**ADDENDUM 1**

**DATE: June 18, 2021**

Contract: 21-C-00017 Beach Park Stormwater Improvements

Item 3: Replace plan sheets 6, 7, 8, 9 and 20 with the attached plan sheets 6, 7, 8, 9 and 20.

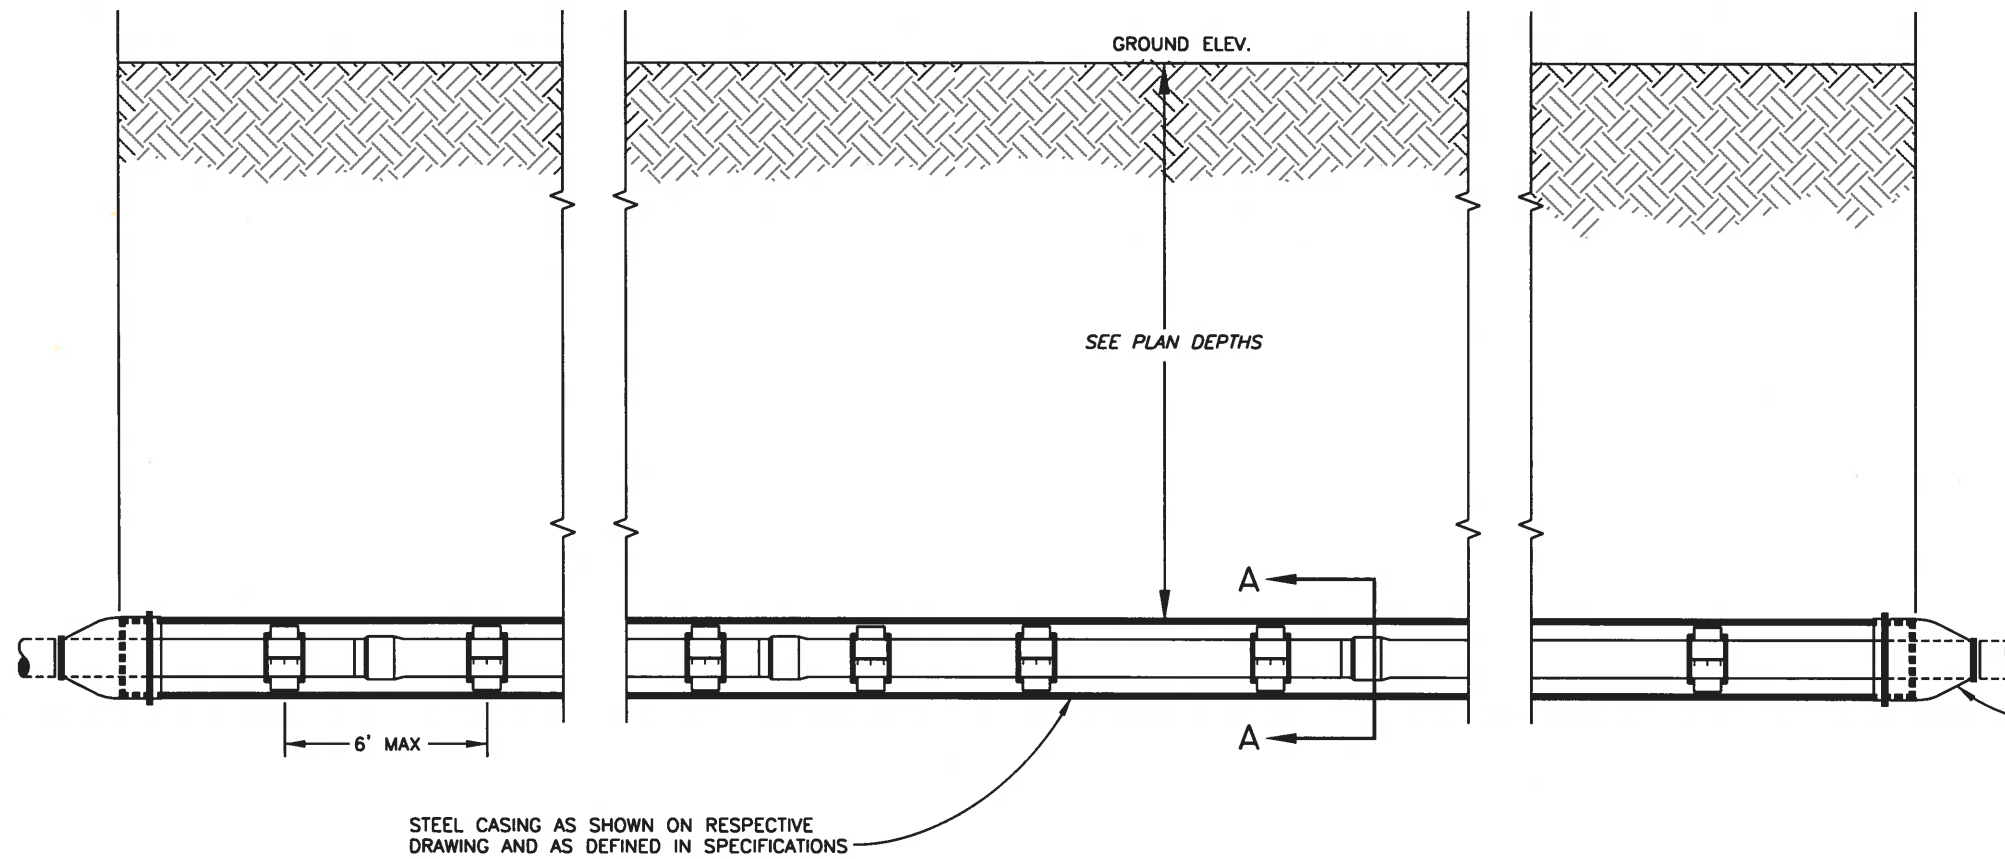
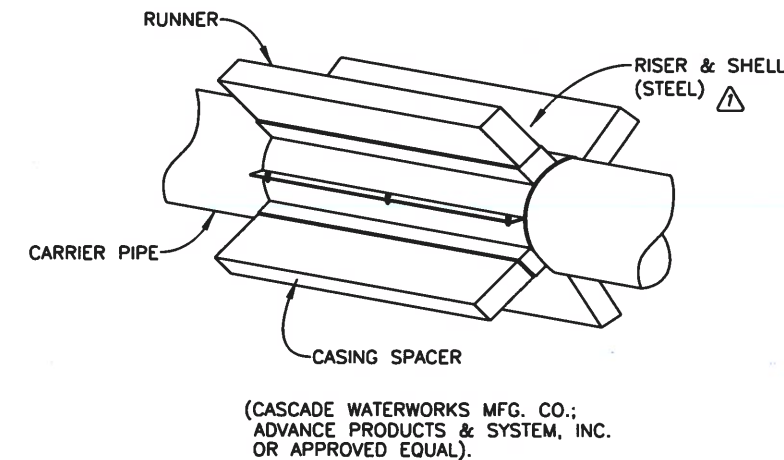
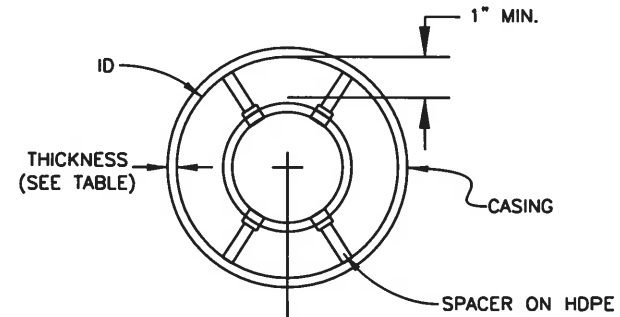
No.	DATE	REVISIONS	No.	DATE	REVISIONS	DES: Y.P.	<b>CITY of TAMPA</b> Mobility Department Stormwater Engineering Division	BEACH PARK STORMWATER DRAINAGE IMPROVEMENTS JACK AND BORE DETAILS	SHEET <b>20</b> OF 21
3			6			DRN: BB			
2			5			CKD: [Signature]			
△	06/16/21	REVISED PIPE TO "STEEL" FROM STAINLESS	4			DATE: 6-2021
